COACH MODEL : T2140, T2145, C2045
DATE : 04/01/2011
SUBJECT : New Hazard Switch Wire Instruction

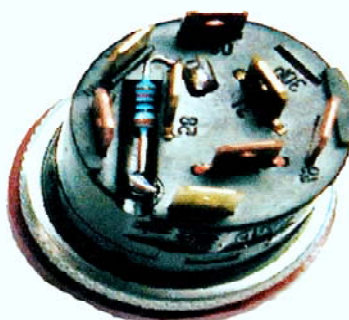
When changing switches a new plug is needed and wiring needs to be modified as shown below. Plug part number is 10753357.

Old plug wiring:

49a: Blue with Violet tracer
49: Blue with orange tracer
30b: Orange with Violet tracer
R: Violet with Yellow tracer
30: Yellow
15: Yellow with Blue tracer
L: Violet
31: Yellow with Blue tracer

New plug wiring:

49a: Blue with Violet tracer
49: Yellow
58: To the grey wire of dashboard rheostat PT2
R: Violet with Yellow tracer
30: Orange with Violet tracer
L: Violet
15: No Wire
30b: No Wire
31: add a Brown wire to Ground stud

(Remove and guard the jumper wire "Yellow with Blue tracer" from the main Yellow with Blue tracer of the coach wiring harness. Then Butt connect the Yellow with Blue tracer wire to the Blue with orange tracer wire.)
